Des Plaines River Watershed Hotel and Casino Development

Recommendations

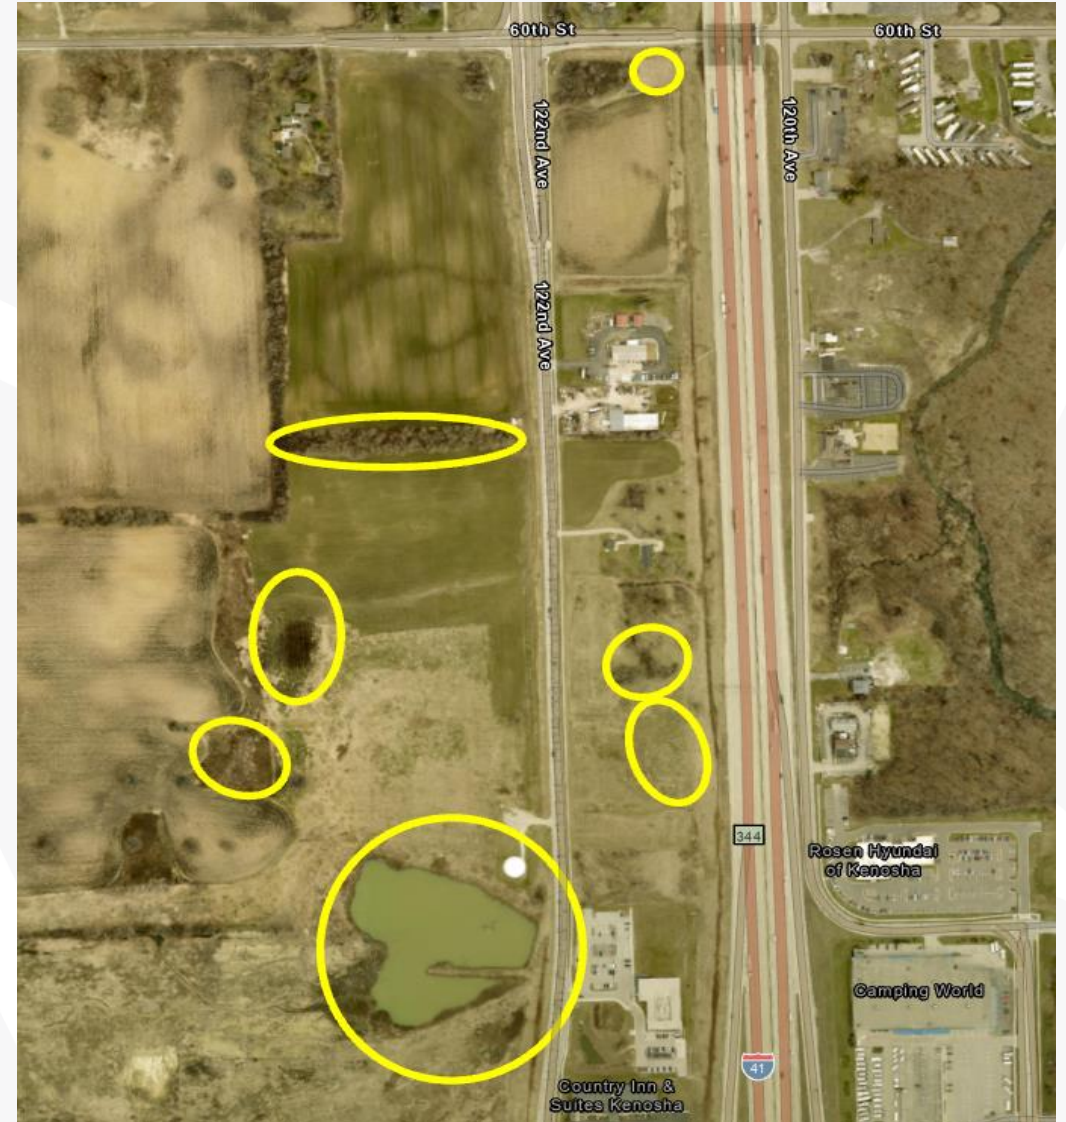
- Compensatory Storage for loss of on-site depressional storage volume.
- Wetland Mitigation within the Des Plaines River Watershed for Waters of the US or wetland impacts.
